DA NO: DA-2023/271
ADDRESS: 27 LAMETTE STREET, CHATSWOOD NSW 2067.
PROPOSAL: ALTERATIONS AND ADDITIONS TO REAR OF EXISTING DWELLING, NEW PATIO, CARPORT, GARAGE AND WORKSHOP AND ASSOCIATED WORKS.
RECOMMENDATION: APPROVAL
ATTACHMENTS:
1. SITE DESCRIPTION AND AERIAL PHOTO
2. DEVELOPMENT CONTROLS, STATISTICS, DEVELOPER CONTRIBUTION & REFERRALS
3. SUBMISSIONS TABLE
4. SECTION 4.15 (79C) ASSESSMENT
5. SCHEDULE OF CONDITIONS
6. NOTIFICATION MAP
RESPONSIBLE OFFICER: CAITLIN MCNALLY - TEAM LEADER
AUTHOR: SAUMYA SHAH - DEVELOPMENT ASSESSMENT OFFICER
REPORT DATE: 27 SEPTEMBER 2024
MEETING DATE FOR PUBLIC MEETING: 15 OCTOBER 2024

The purpose of this report is to seek determination by Willoughby Local Planning Panel (WLPP) of Development Application DA-2023/271 for alterations and additions to rear of existing dwelling, new patio, carport, garage and workshop and associated works at 27 Lamette Street, Chatswood.

Figure 4: Ground Floor Plan

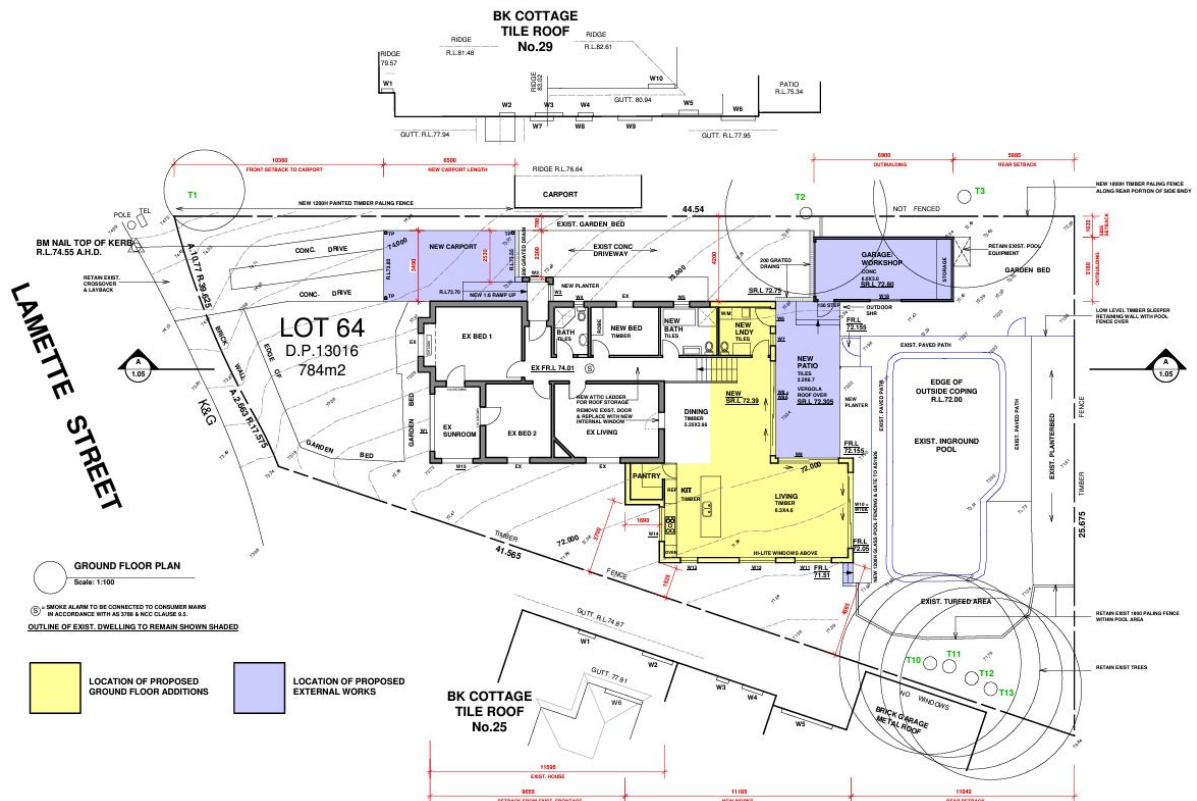
- The subject site is uneven in shape and located on the cul-de-sac of the Lamette Street
- The proposed new carport is 1m forward of the predominant front building line of the subject dwelling; however, it maintains the predominant front building line of the northern side dwellings on the Lamette Street.

- Amended set of plans indicate the roof design of the proposed carport to be hipped at the front to reduce the mass and bulk impact from the streetscape and also to maintain the characteristics of the dwelling in a heritage conservation area

- Amended set of plans also indicate the removal of the solar panels from the roof of the proposed carport to reduce the mass and bulk impact to the streetscape and to the neighbouring property

- The proposed new carport provides 0.7m of side setback from the northern boundary, which is noncompliant to *WDCP* controls. However, the carport will be a semi-open structure which will not deliver unreasonable impact to the neighbouring property. The proposed addition provides 1.5m to of minimum side setback from the southern boundary, which is compliant to *WDCP* controls.
- The proposed design of the carport structure will maintain the heritage characteristics of the surrounding development.
- The scale of the work proposed with this application is unlikely to cause an adverse impact on surrounding residential amenity nor set an undesirable precedent.

- (1) The proposed garage must have minimum dimensions of 3m x 5.4m, clear of any obstructions, to comply with AS2890.1. This required dimensions and the design envelope around parked vehicle as per Figure 5.2 of AS2890.1 are to be clearly depicted on the architectural plans.

- (a) Proposed window W13 is required to provide frosted glass/translucent glass treatment to a minimum height of 1.6m from F.F.L. to mitigate the privacy impact from the neighbouring property.

Figure 5: Landscape Plan

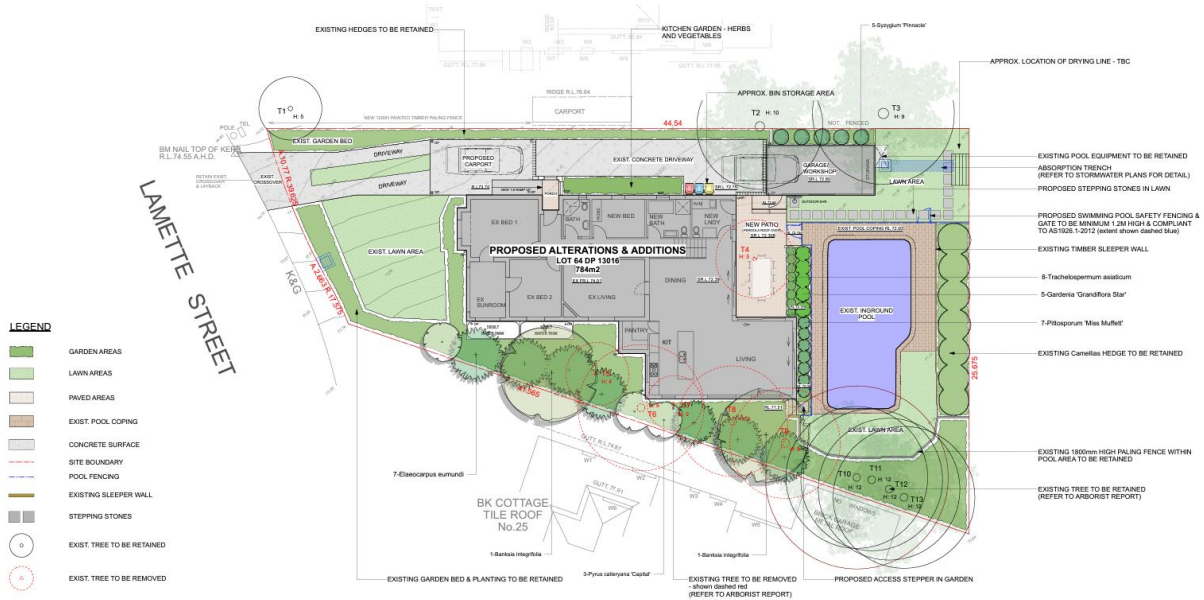
<p>The plans and AIA indicate a total of six (6) trees for removal. Trees 7, 8 & 9 are exempt species and can be removed without consent.</p> <p>Trees 4, 5 & 6 are exotic species all with a low retention value and should not be considered a constraint to the development. There are no objections the removal of these subject to replacement at 3:1 as per <i>Willoughby DCP</i> Part G. A minimum of nine (9) trees shall be required for replacement.</p> <p>Trees 1, 2 & 3 are located on the neighbouring site and are to be retained. There will be no impact to tree 1.</p> <p>The works to the garage and stormwater services are located within the tree protection zone (TPZ) of trees 2 & 3. The garage is located in the same position as the existing garage, so not expected to impact on the trees.</p> <p>The absorption trench is located within the TPZ of tree 3. To minimise impacts to the tree the absorption trench is to be located at least 4m from the trunk of tree 3 and a Project Arborist to supervise works. A condition has been added.</p> <p>Trees 10 – 13 located within the site are outside the area of proposed area of work. There should be no impact to these trees.</p> <p>The plans show the rainwater tanks are located aligned to the front building, which will be visible from the street.</p> <p><i>WDCP</i> Part I - Stormwater Management; 2.5 Controls for rainwater reuse tanks c. Rainwater tanks must be positioned or screened so as not to be visible from the street frontage.</p> <p>The rainwater tanks are to be setback at least 1m from the front of the building and to be screened with planting. A condition has been added.</p> <p>There are no objections with regard to landscape issues subject to the conditions.</p>

Approval is given for the removal of the following trees as identified on the Landscape Plan Dwg. No. C1 rev. C dated 18/3/2024 Prepared by Contour Landscape Architecture:

No. Required	Species	Location	Min Pot Size
All trees	As indicated on Landscape Plan Dwg No. C1 Rev. C dated 18/3/2024 prepared by Contour Landscape Architecture	As indicated on the Landscape Plan	As indicated on the Landscape Plan
